December 03, 2009  
NRC-09-0070

Subject: Enrico Fermi Atomic Power Plant, Unit 1  
Information Regarding the Fermi 1 License Termination Plan

The NRC requested that certain documents be submitted and docketed to aid in their technical review of the Enrico Fermi Unit 1 (EF1) License Termination Plan (LTP).

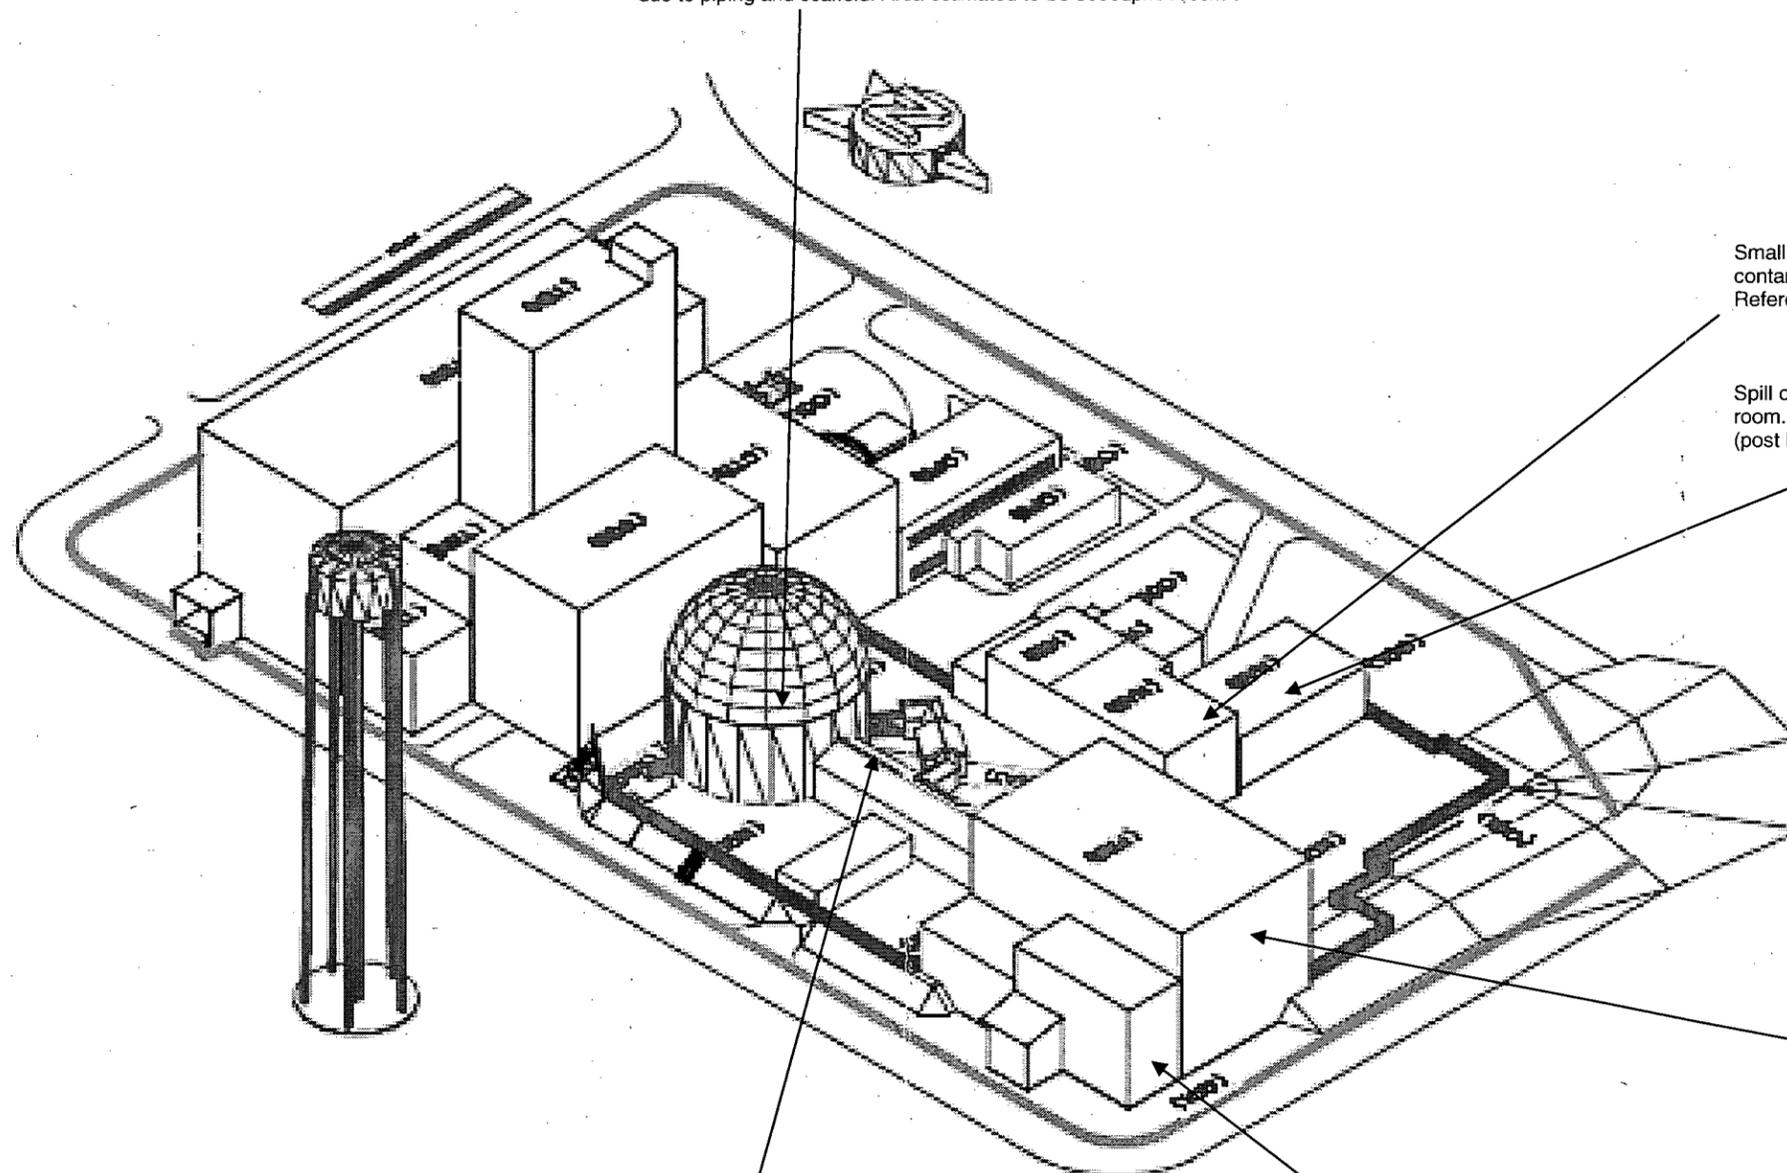
*Q. If not already provided, provide information on the radiological characterization of the site. This would include residual radioactivity in all media (including buildings, systems and equipment that will remain after license termination, surface and subsurface soil, and surface and subsurface ground water), characterization of the radiological status (e.g., process historical development, records of leakage or disposal), and clearly relate the information provided in the discussion of radiological status of the site with the discussion of source-term abstraction. Maps and cross-sections would be of benefit when detailing the extent of residual radioactivity left on the site.*

Fire in the Reactor Bldg. basement referenced -in sections 2.1.6 and 2.1.8.7 of the LTP. Basement was decontaminated to <math><500 \text{ dpm}/100\text{cm}^2</math> with the exception of the area directly under the fire which was inaccessible due to piping and scaffold. Area estimated to be  $8000\text{dpm}/100\text{cm}^2$ .

Small spills in the Cold Trap room. Average contamination levels of  $1000 \text{ dpm}/100\text{cm}^2$ . Referenced in section 2.1.8.10 of the LTP.

Spill occurred in the Primary Sodium Storage Tank room. Average contamination of  $2000\text{dpm}/100\text{cm}^2$  (post LTP submittal).

A spill from intermodal in FARB was up to  $2 \text{ million dpm}/100\text{cm}^2$  fixed contamination. Spill occurred after LTP was submitted.

Location of break in Radwaste discharge line referenced in sections 2.1.6 and 2.1.8.1 of LTP. Historical samples indicated no activity and Well # EF-9S was located at this site. The pipe will be excavated and the surface beneath the pipe will be surveyed

Minor leaks of sodium mentioned in the Trestle way and referenced in sections 2.1.6 and 2.1.8.9 of the LTP.

A site map is submitted with the locations of historical spills. The radiological characterization was provided in the EF1 Historical Site Assessment submitted in Reference 4.

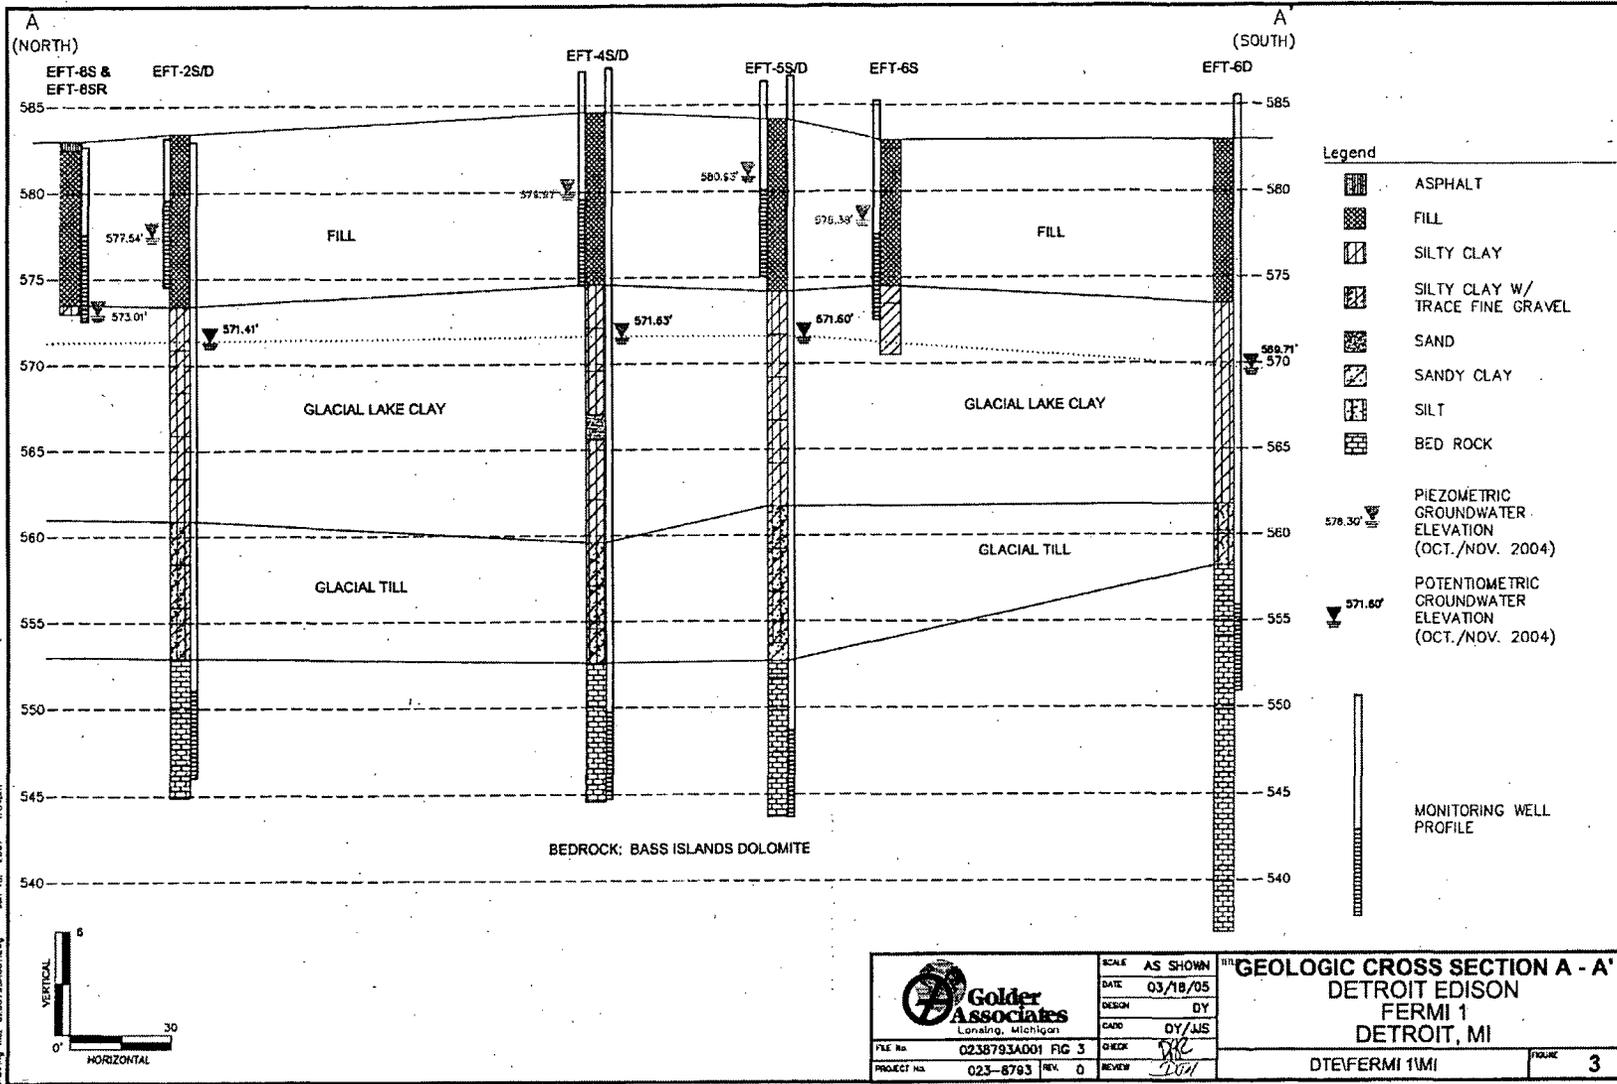
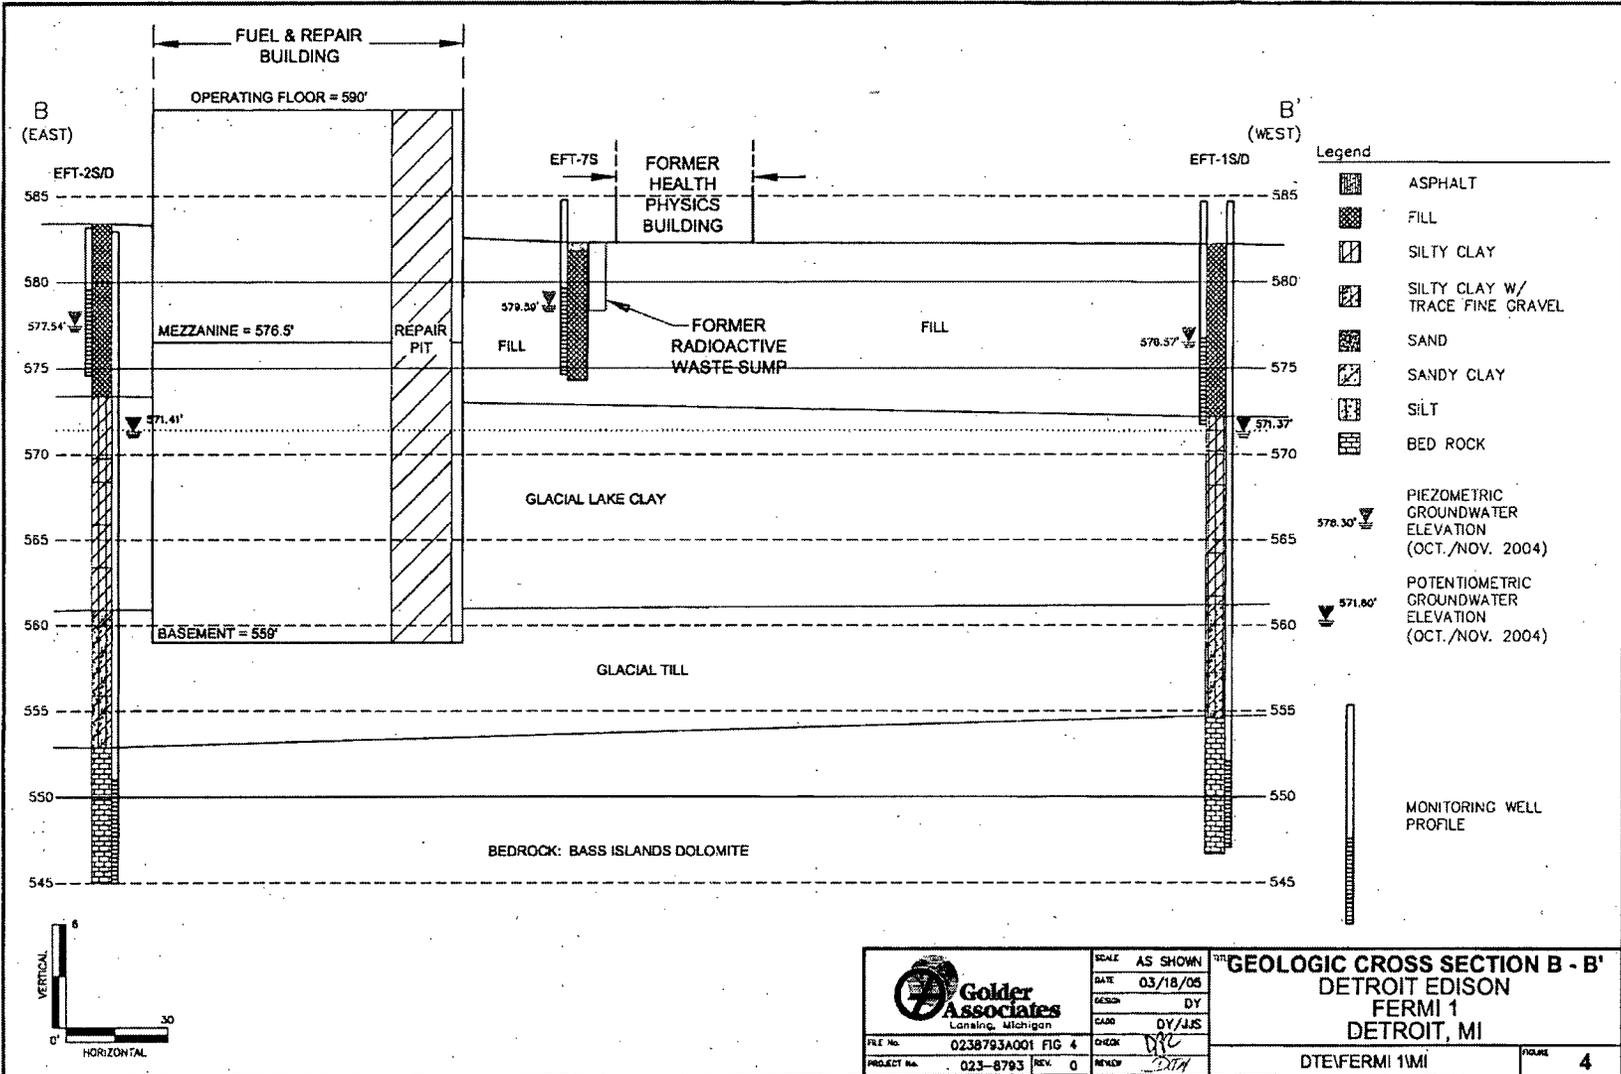
*Q. App. 6F, Sec. 3 "Contaminated Zone Erosion Rate," p. 6-49: The relationship between two groundwater monitoring wells and the erosion rate is not clear. If the topographic elevation of the two well localities were used in order to determine the slope between the two topographic points, the representativeness of these two points for the site slope would need to be demonstrated.*

The RESRAD model uses a default value of an annual erosion rate equal to 0.001 m/y for both the cover and contaminated zones. The modeling for the Fermi 1 site did not include a cover, thus, the only erosion rate required was that for the contaminated zone. Rather than using the RESRAD default erosion rate, an erosion rate for the Fermi 1 site was determined from site-specific information provided in the Golder Associates report. This determination was enabled because the RESRAD modeling guidance cited above and Attachment C to NUREG/CR-6697 both provide erosion rates based on slope. The slope based on elevations of and distance between wells 10S and 8S (1.9%) was used as the basis for selecting the erosion rate input value ( $6 \times 10^{-4}$  m/y, which should be assumed for a 2% slope). The calculated slope (1.9%) is supported as a representative site slope by Figures 3 and 4 in the "Report on Groundwater Characterization – Enrico Fermi 1 License Termination" issued by Golder Associates Inc. Figure 3 shows the geologic cross section, including an elevation profile, for the Protected Area at the Fermi 1 site in the north-south direction. As shown in that figure, well 4S is located at the highest elevation near the mid-point of the north-south length of the Protected Area. This creates 2 potential slopes: one slope from well 4S to lower site elevations to the north and another slope from well 4S to lower elevations to the south. The slope from well 4S to well 8S approximately 145 ft to the north is approximately 1.1%. A similar slope exists to the south of well 4S. The slope from well 4S to well 6D (a distance of about 180 ft) is approximately 0.9%.

The geologic cross section, including an elevation profile, in the east-west direction is provided by Figure 4. The site slope from well 2S to well 1S, separated by a distance of approximately 320 ft across the span of the Protected Area, is approximately 0.4%.

The elevation profiles shown in these 2 figures provide additional support that the use of an erosion rate based on a site slope of 1.9% is representative for the Fermi 1 site.
